DESIGN AND ACCESS STATEMENT ADDENDUM

Former Clough Mill, Clough Road, Slaithwaite - Planning Application 2025/93543/W

Design Evolution and Response to Officer Comments

Bill Best drawing - SK04, 01.07.2024

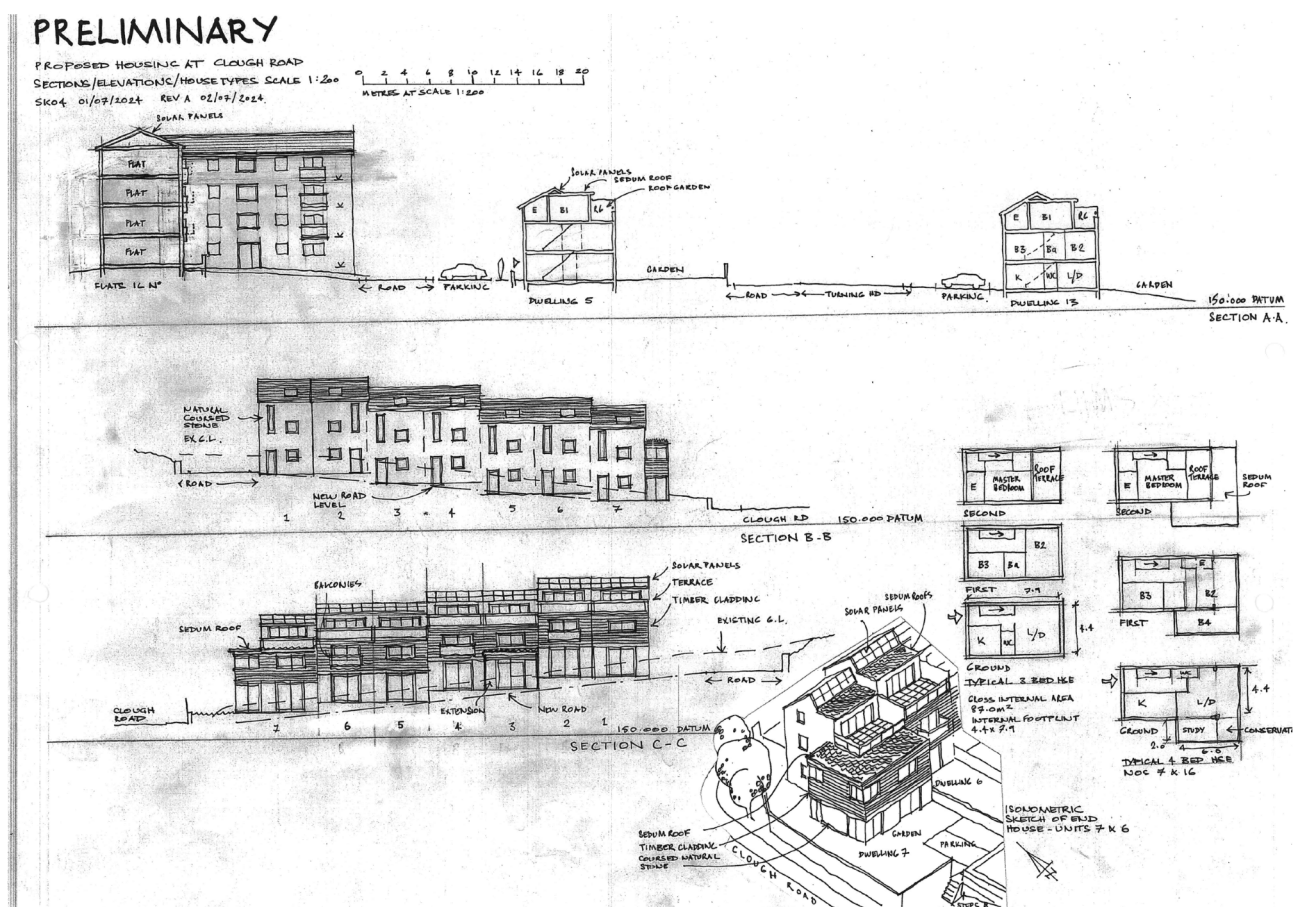
The July 2024 drawing included apartments presenting a gable end towards Clough Road and more contemporary housing forms incorporating roof terraces, sedum roofs, timber cladding, balconies and solar panels.

This study is useful because it demonstrates that a more direct relationship between buildings and Clough Road has formed part of the design exploration from an early stage.

However, the approach was subsequently refined. The more contemporary architectural language was simplified to respond more closely to the established Colne Valley character, including a more traditional material palette and simpler window and roof treatment.

The sedum-roof approach was also removed as the design evolved.

3.2 Parker Peel Sketch Layout Option 1

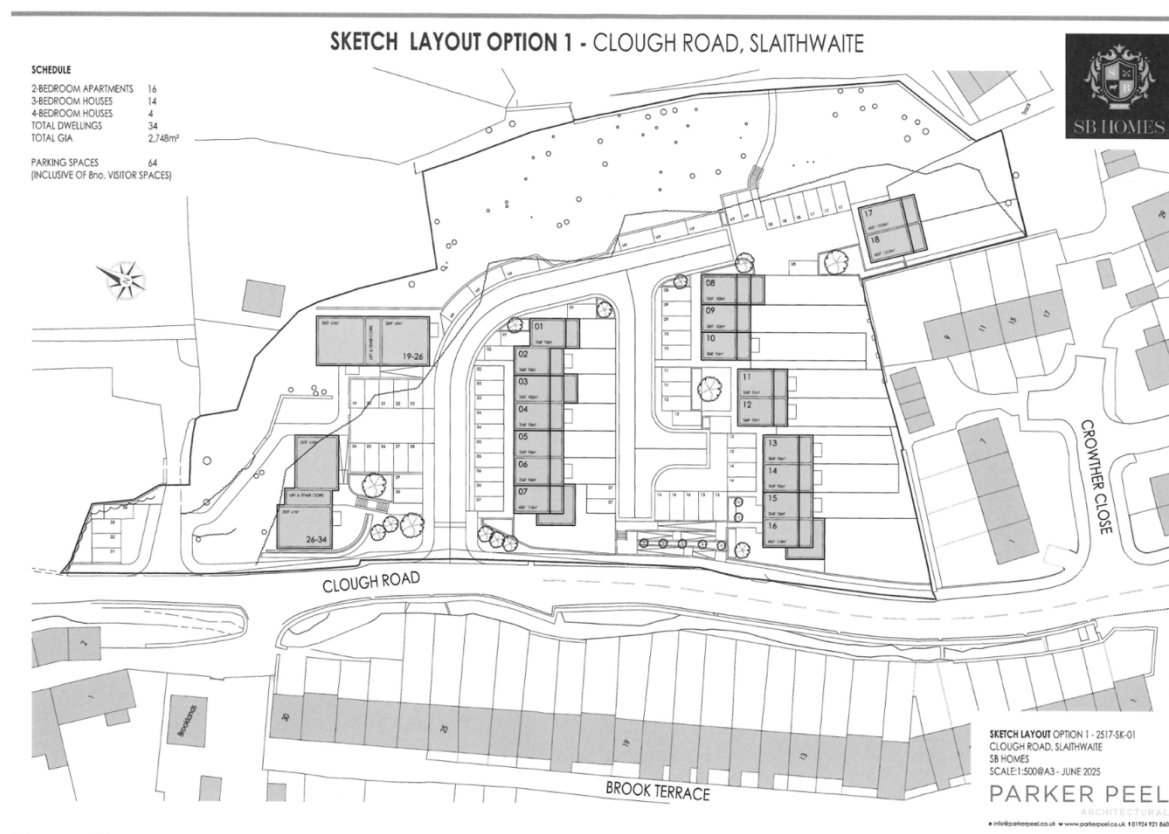
A subsequent Parker Peel sketch layout again tested a materially different arrangement of development.

The drawing shows 34 dwellings and demonstrates the extent to which different relationships between the apartment building, houses, parking, access and Clough Road were considered before the current layout evolved.

3.3 Specific appraisal of turning the southern houses

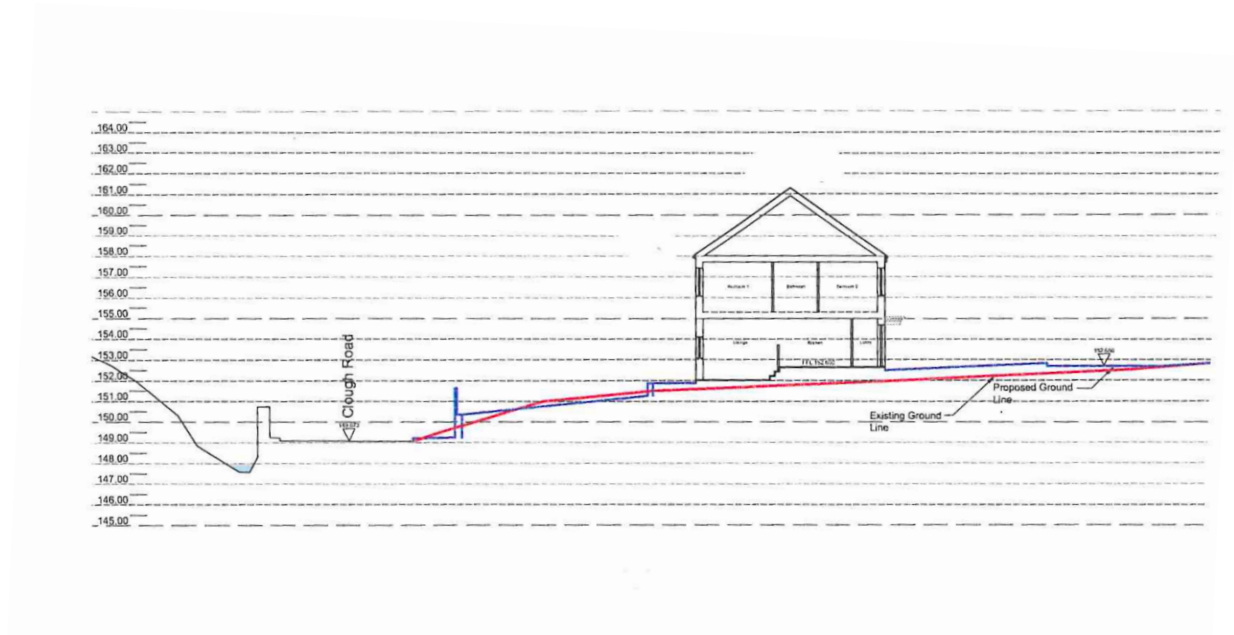
More recently, the design team specifically tested the Planning Officer's suggestion by examining what would happen if the southern group of houses were turned through approximately 90 degrees.

The appraisal sketches expressly identify an **“examination of former plots 8 to 16 turned through 90°”**, together with the resulting garden, parking and retaining-wall arrangements.

The Applicant is not relying simply upon an assertion that the Officer's suggested arrangement would not work. An alternative arrangement has actually been drawn and considered.

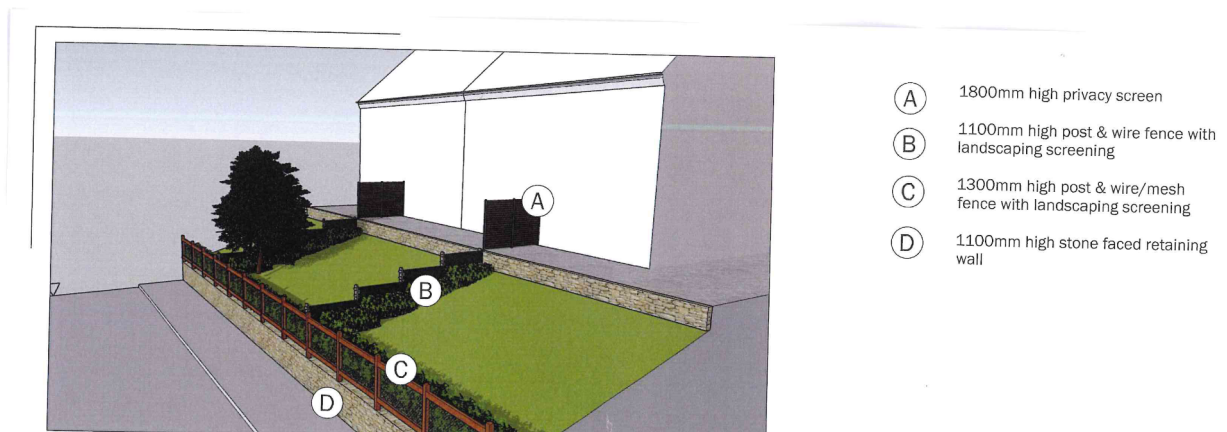
At the southern end, around Plot 16, the development platform is approximately **4 metres higher than Clough Road.**

Turning the house through 90 degrees does not remove that level difference.

A house could face the road architecturally, but it would still sit materially above it.

To produce a conventional relationship between house, garden and road, one of three things would therefore have to happen.

Option C – lower the houses towards Clough Road

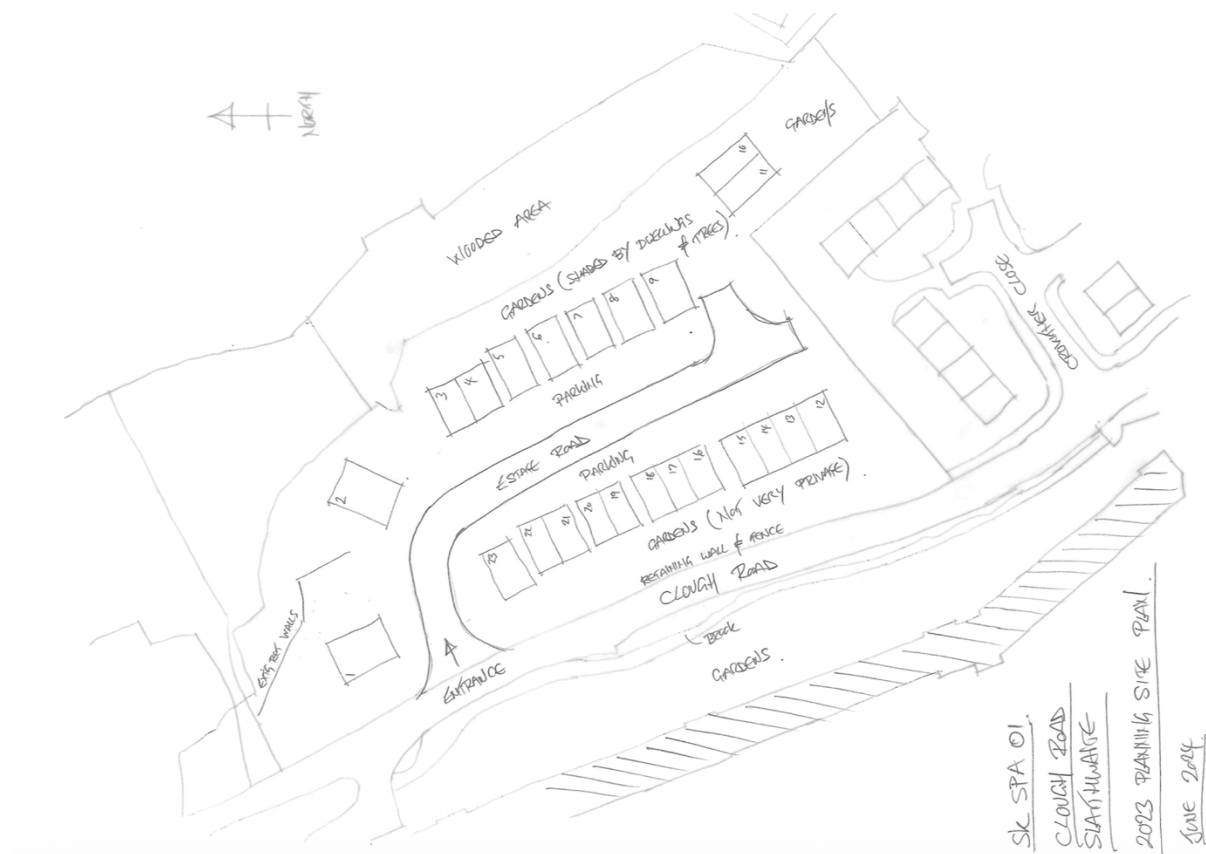
The third alternative would be to lower the dwellings substantially towards road level.

That would simply move the engineering problem elsewhere.

Significant excavation and retaining structures would then be required behind the houses as the land rises into the development.

It would also make the relationship between the first and second rows of development considerably more difficult.

For these reasons, the level difference cannot be designed away merely by rotating the houses.

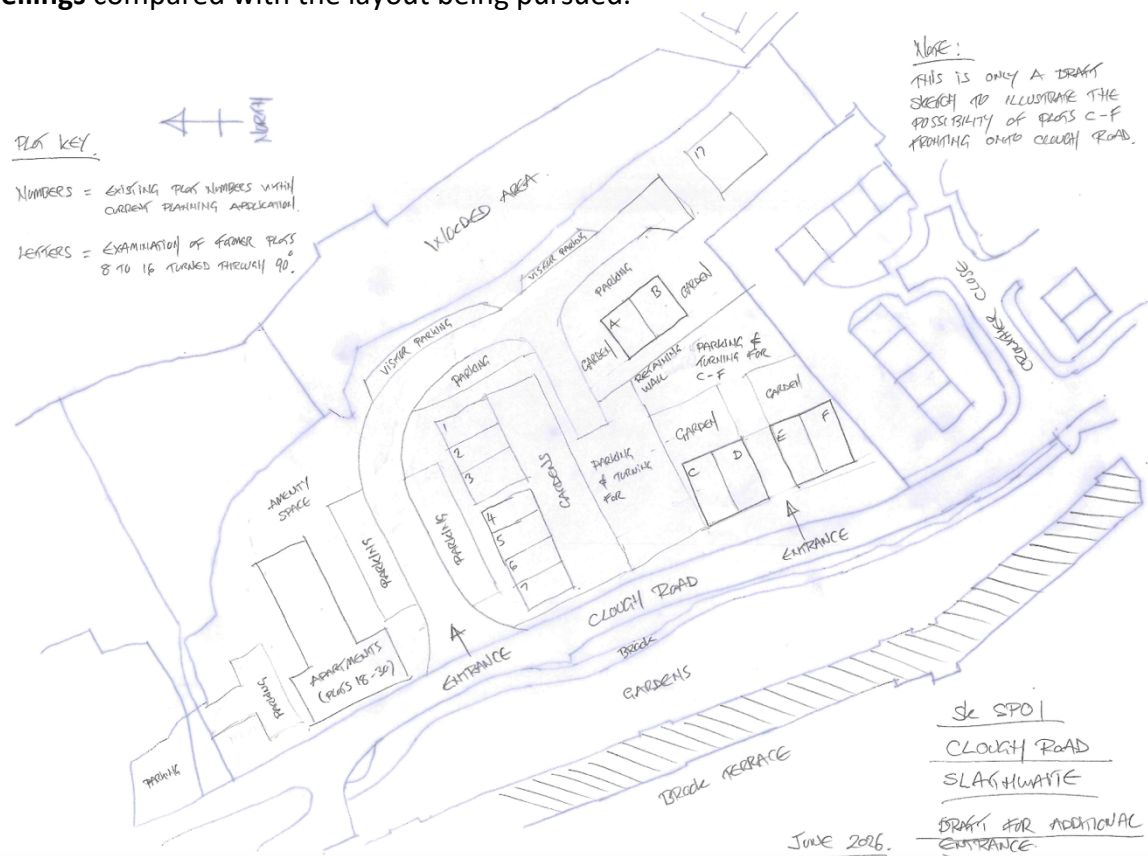
The outlook includes the wider Colne Valley and the listed Crimble Viaduct, providing a distinctive sense of place.

The terraces and balconies have deliberately been positioned to take advantage of this outlook.

The orientation enables principal terraces and balconies to take advantage of long views across the Colne Valley, including towards Crimble Viaduct, reinforcing the relationship between the development and its distinctive landscape setting.
